# 125C

<b>Parts List No.</b> 530165592		<b>Husqvarna</b> ® PARTS LIST	<b>MODEL</b> 125C
<b>Date</b> 2/01/08	<b>Replaces</b> 530165592 - 9/14/07		<b>NOTE</b> : Illustration may differ from actual model due to design changes.

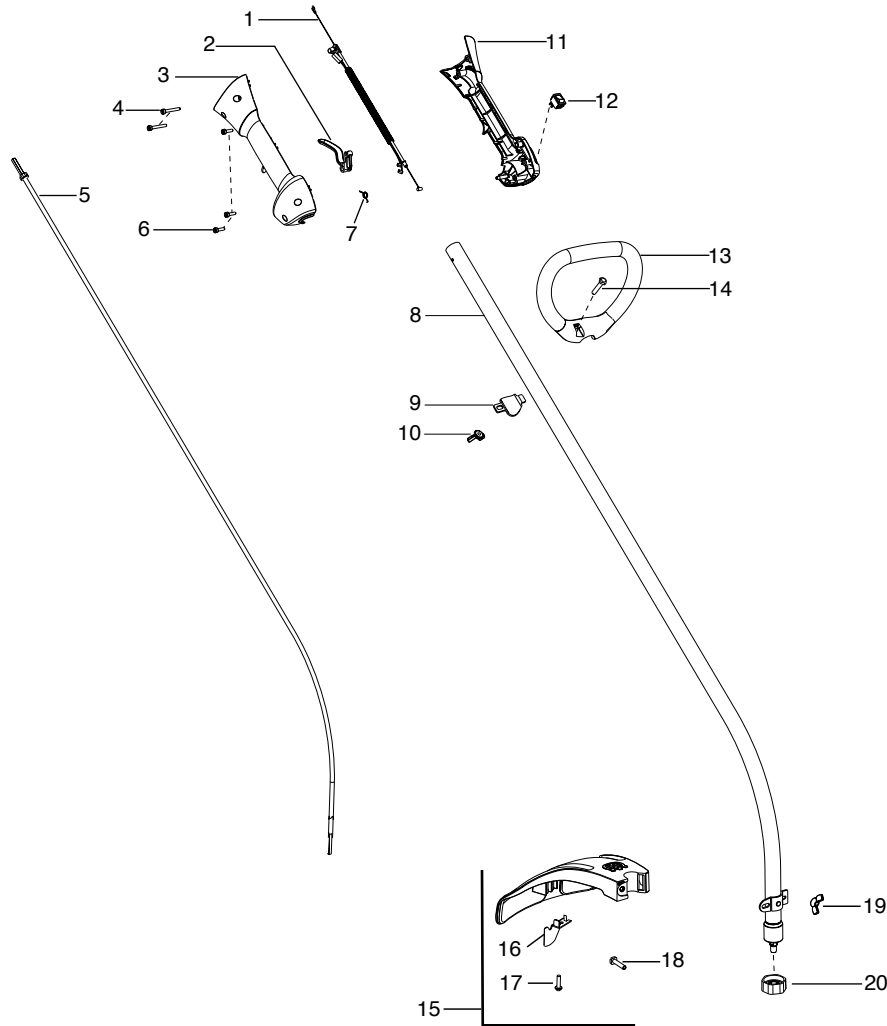
Note : Due to product improvements, your unit may have a different clutch drum assembly and flexshaft.  
Please refer to the serial number on your unit and order the parts below.

Serial Number - 06119N and lower, please use the following parts:  
 Page 1, Ref.# 5 - 545006053 Kit - Clutch drum & flexshaft  
 Page 2, Ref.# 51 - 545006053 Kit - Clutch drum & flexshaft

Serial Number - 06120N and higher, please use the following parts:  
 Page 1, Ref.# 5 - 530096314 Flexshaft  
 Page 2, Ref.# 51 - 545106801 Assy-Clutch drum with adapter

Note : Due to product improvements, your unit may have a different clutch drum assembly and flexshaft.  
Please refer to the serial number on your unit and order the parts below.

Serial Number - 07333N and lower, please use the following parts:  
 Page 1, Ref.# 5 - 545006053 Kit - Clutch drum & flexshaft  
 Page 2, Ref.# 51 - 545006053 Kit - Clutch drum & flexshaft

Serial Number - 07334N and higher, please use the following parts:  
 Page 1, Ref.# 5 - 545007508 Flexshaft  
 Page 2, Ref.# 51 - 530150039 Assy-Clutch Drum
